## Access Compliance Report Public Rights-of-Way (Curb Ramps)

Intersection ID: 26208 Main Street: BALLANTRAE\_VILLAGE\_DR Cross Street: ELM LN Location: SE

ADA ID: 128FDFF3789C Ramp Type: Perp Initial Pass/Fail: Fail Overall Compliance: No Severity Score: 33.75

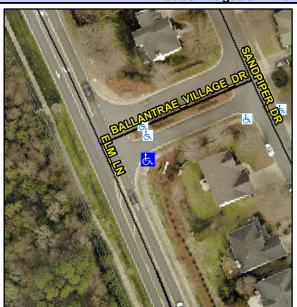
R304.5.1, R304.5.3

Field Measurements/Component Compilance						
	Compliance Description		Data	Compliance Description		Data
	N/A	Ramp Length (in)	107.0	Yes	Ramp Slope (%)	8.0
	No	Ramp Width (in)	42.0	No	Ramp XSlope (%)	7.4
	N/A	Flare Type LT	N/A	N/A	Flare Type RT	N/A
	N/A	Flare Slope LT (%)	N/A	N/A	Flare Slope RT (%)	N/A
	N/A	Flare Traversable LT?	N/A	N/A	Flare Traversable RT?	N/A
	N/A	Landing Length (in)	N/A	N/A	DWS Provided?	N/A
	N/A	Landing Width (in)	N/A	N/A	DWS Contrast?	N/A
	N/A	Landing Slope (%)	N/A	N/A	DWS Length (in)	N/A
	N/A	Landing X Slope (%)	N/A	N/A	DWS Full Width?	N/A
	N/A	Landing Curb? (Y/N)	N/A	N/A	DWS Offset (in)	N/A
	N/A	Shared Landing?	N/A			
	N/A	Gutter Ponding?	N/A	N/A	Gutter Slope (%)	N/A
	N/A	Gutter Lip Ht (in)	N/A	N/A	Gutter X Slope (%)	N/A
	N/A	Painted X Walk1?	No	N/A	Painted X Walk2?	N/A
		X Walk 1 Direction	To NE		X Walk 2 Direction	N/A
	N/A	X Walk 1 Width (in)	N/A	N/A	X Walk 2 Width (in)	N/A
		X Walk 1 Slope (%)	2.6		X Walk 2 Slope (%)	N/A

X Walk 1 X Slope (%)	8.3		X Walk 2 X Slope (%)	N/A
	N/A	Ramp inside XWalk1?	N/A	N/A	Ramp inside XWalk2?	N/A
		Road Slope (%)	N/A	N/A	Clear Space?	N/A
		Road X Slope (%)	N/A	N/A	Clear Space to XWalk (in)	N/A
	N/A	Any Obstructions?	N/A	N/A	Storm Grate/Utility Hazard?	N/A
		Obstruction Type			Storm Grate/Utility Type	
			N/A			N/A
				Yes	Surface Condition? (G/P)	Good

Remove & Replace Entire Ramp.
